UNITED STATES PATENT AND TRADEMARK OFFICE

APPLICATION NO.	FILING DATE	FIRST NAMED INVENTOR	ATTORNEY DOCKET NO.	CONFIRMATION NO.
09/804,198	03/13/2001	Rikuro Obara	2523-061	9185

Office Action Summary

DETAILED ACTION

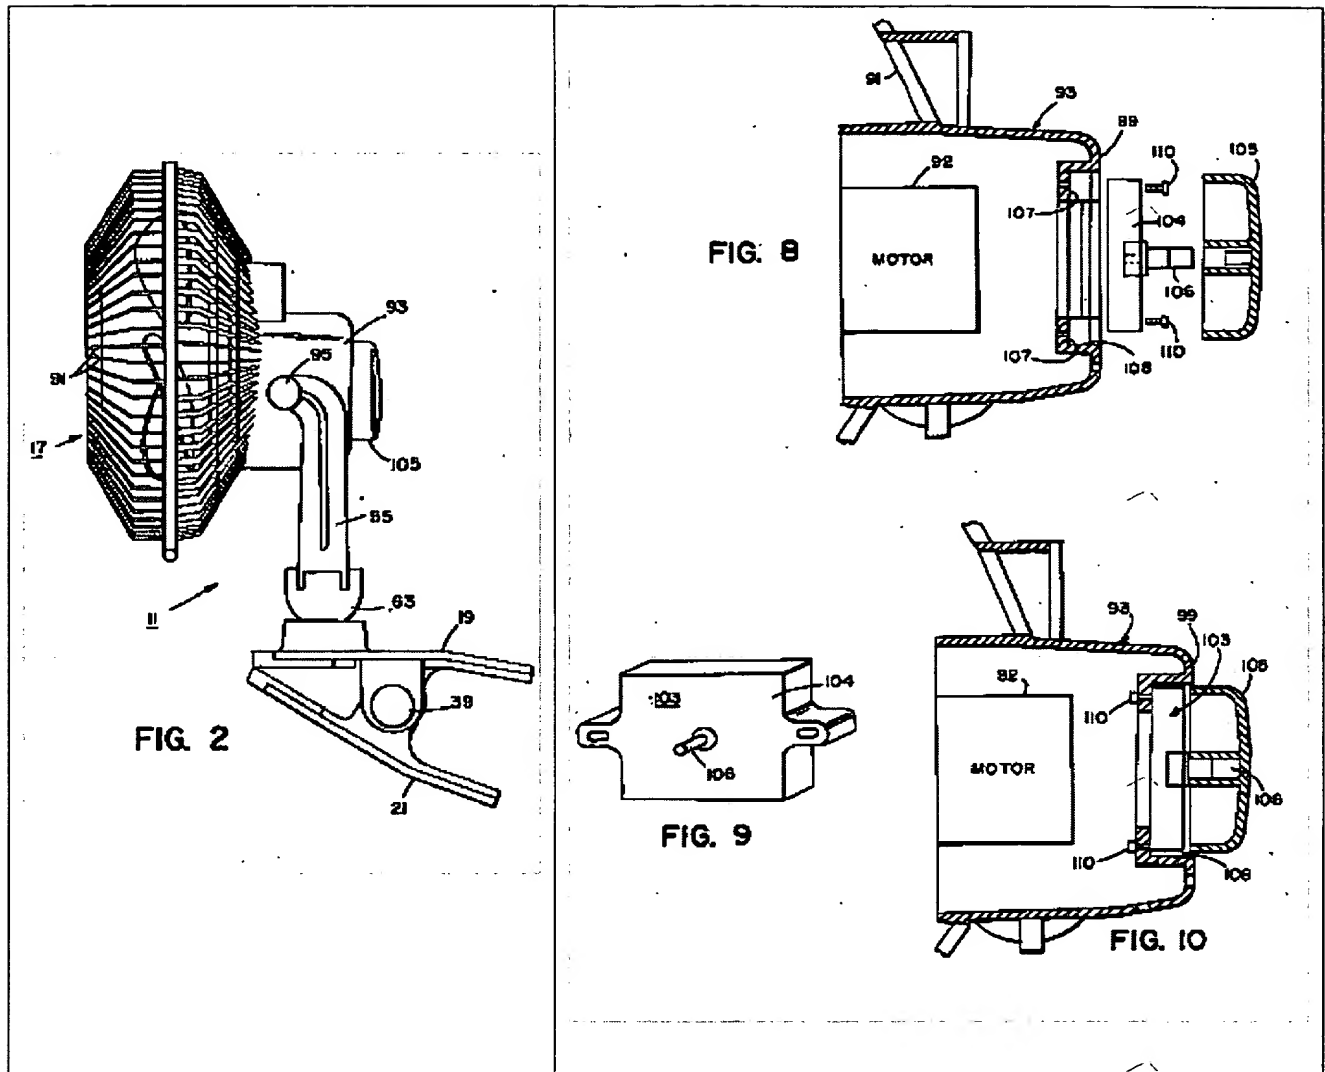
Shin-Chin, Figures 2 & 8-10 as displayed above disclose according to applicant's claims 1, 3, 6, 7 & 8, a blower (17) having an impeller (89) rotated by means of a motor (92), comprising: a base (93) for supporting the motor (92) in a frame (17), the base

JK
9/16/03 (93) provided at a central portion of the frame ¹⁷(93), a chamber {inside (93) and where (103) is located} with a front and back portions {(99), (105)} formed in the base (93), wherein the chamber is formed by the base (93) having a flange (99) extending to from the back portion from an outer periphery thereof forming a cylindrical body with a closed end for accommodating electrical components (103), and wherein the back portion of the chamber is at a downwind side and is occluded and sealed by a removable cover (105). See Shin-Chin, Figures 1-10 and respective portions, abstract, col. 4 lines 6-22 of the detailed description.

Shin-Chin, Figures 2 & 8-10 as displayed above disclose according to applicant's claims 1, 3, 6, 7 & 8, a blower (17) having an impeller (89) rotated by means of a motor (92), comprising: a base (93) for supporting the motor (92) in a frame (17), the base (93) provided at a central portion of the frame (17), the base (93) supported {concentrically} at the central portion of the frame by stays (91), a chamber {inside (93) and where (103) is located} with

a front and back portions {(99), (105)} formed in the base (93), wherein the chamber is formed by the base (93) having a flange (99) extending to from the back portion from an outer periphery thereof forming a cylindrical body with a closed end for accommodating electrical components (103), and wherein the back portion of the chamber is at a downwind side and is occluded and sealed by a removable cover (105). See Shin-Chin, Figures 1-10 and respective portions, abstract, col. 4 lines 6-22 of the detailed description.

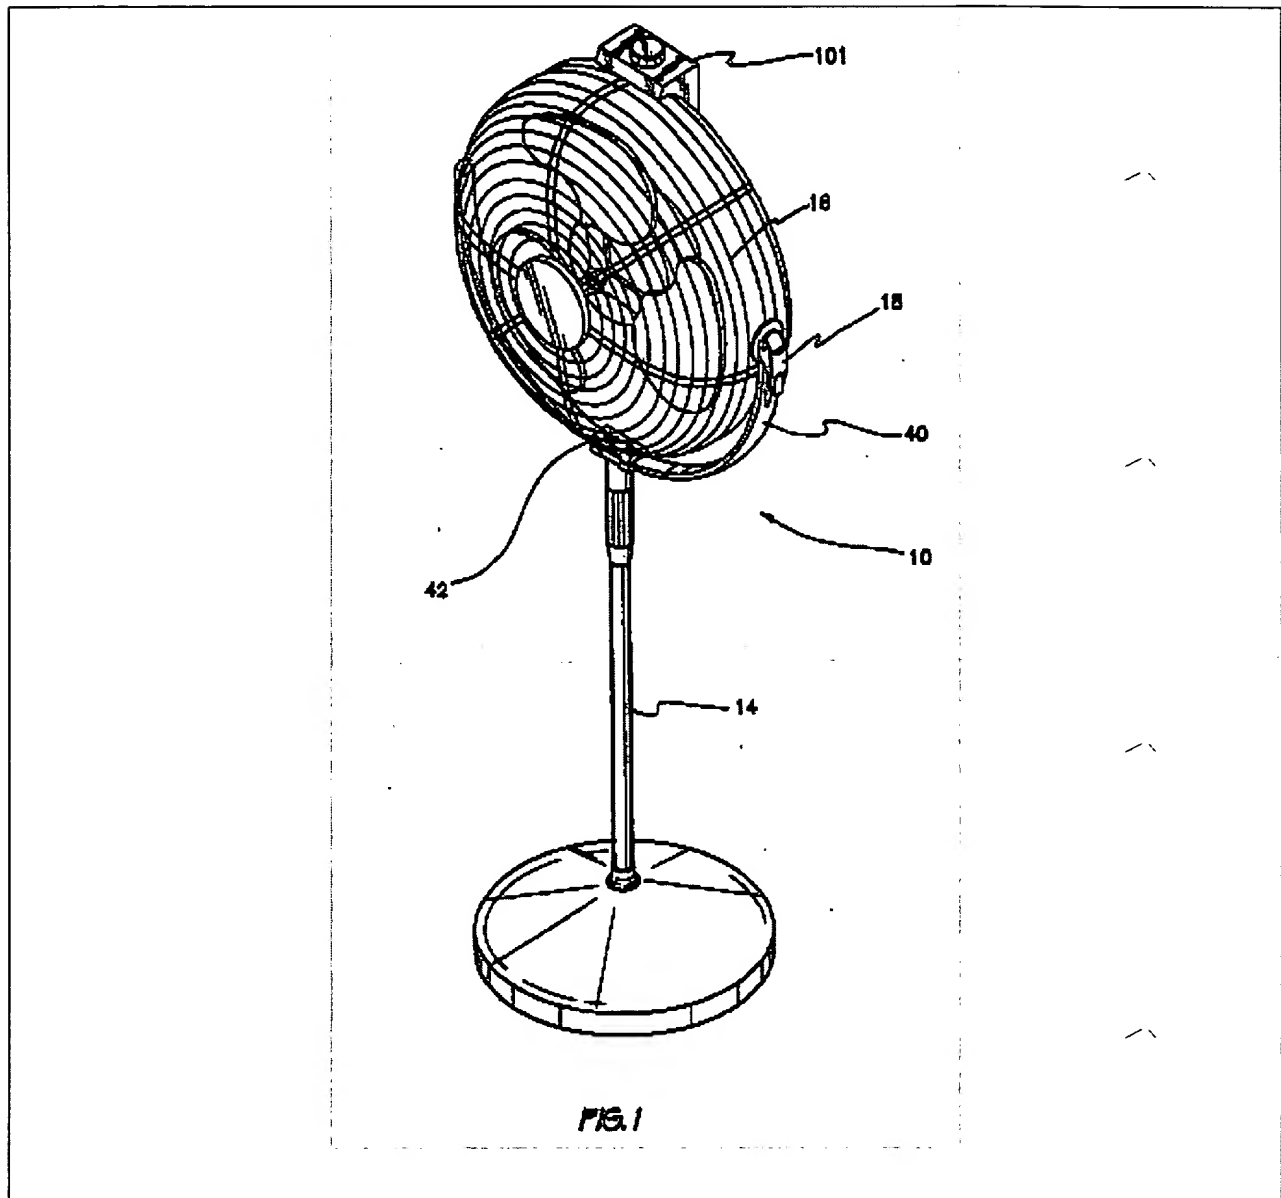
Shin-Chin does not disclose the base (93) supported {directly} at the central portion of the frame by stays (91).

Wolfe et al., Figure 1 as immediately displayed above discloses a fan (10) where the motor base (2) is supported by stays (16) via u-

frame (40). See Wolfe et al., Figures 1 & 2 and respective portions, abstract, col. 2 lines 64-67 & col. 3 lines 1-18 of the detailed description.

It would have been obvious to an artisan of ordinary skill in the art at the time the invention was made to take the fan blower of Shin-Chin and modify it according to Wolfe et. al so as to support the fan in an alternative fashion for esthetic purposes.
